WCAP-17504-NP-A
Revision 1

Westinghouse Generic Setpoint Methodology

SUBJECT: FINAL SAFETY EVALUATION FOR WESTINGHOUSE ELECTRIC COMPANY
TOPICAL REPORTS WCAP-17503-P/WCAP-17503-NP, REVISION 1,
"WESTINGHOUSE GENERIC SETPOINT CONTROL PROGRAM
RECOMMENDATIONS" AND WCAP-17504-P/WCAP-17504-NP, REVISION 1,
"WESTINGHOUSE GENERIC SETPOINT METHODOLOGY"
(TAC NO. ME8115)

Figure 3-1 Westinghouse Setpoint Parameter Relationship Diagram (Increasing Function)

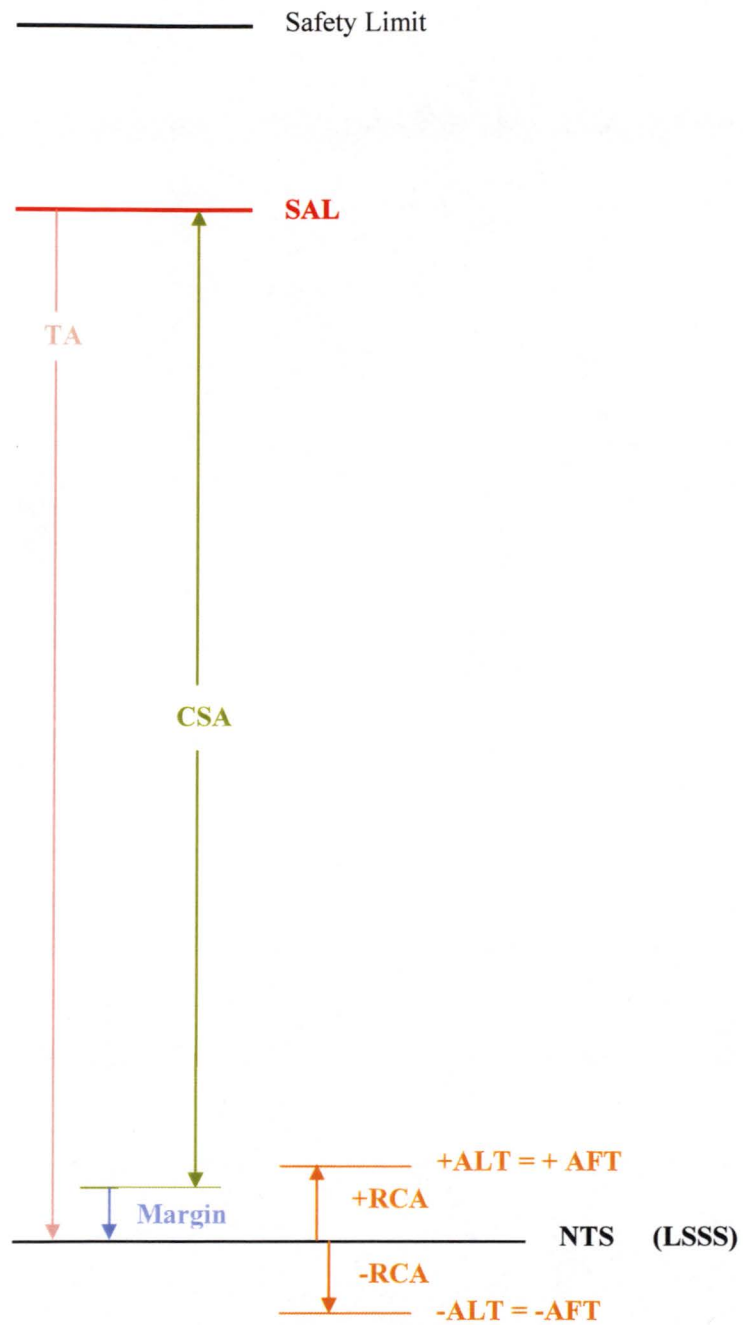
The NRC staff finds that WCAP-17504-P/WCAP-17504-NP, Revision 1, adequately describes the important relationships among Safety Limit, Analytical Limit, Limiting Trip Setpoint, Allowable Value, Setpoint, Acceptable AFT Band, Acceptable ALT Band, and Setting Tolerance. Based on the discussion of terms and relationships presented in the WCAP-17504-P/WCAP-17504-NP, Revision 1, and the sample calculations, tables, and figures presented in WCAP-17504-P/WCAP-17504-NP, Revision 1, the NRC staff finds that the Westinghouse setpoint methodology demonstrates that the correct relationships between the SL, AL, NTSP, AFT, and ALT will be ensured, that the basis for the NTS is correct, and that the requirements of GDC 13 and 20 are met.

Therefore, the WSM described in the WCAP-17504-P/WCAP-17504-NP, Revision 1, uses double-sided evaluation acceptance criteria bands. Figure 3-1 (above) and the relationships described above illustrate how the operability of the instrument loop is evaluated. Exceeding the AFT in either high or low direction may indicate degraded performance and inability of the instrument channel to meet its intended function. Not being able to reset the setpoint to within the ALT at the conclusion of a channel calibration process also may indicate degraded performance and inability of the instrument channel to meet its intended function.
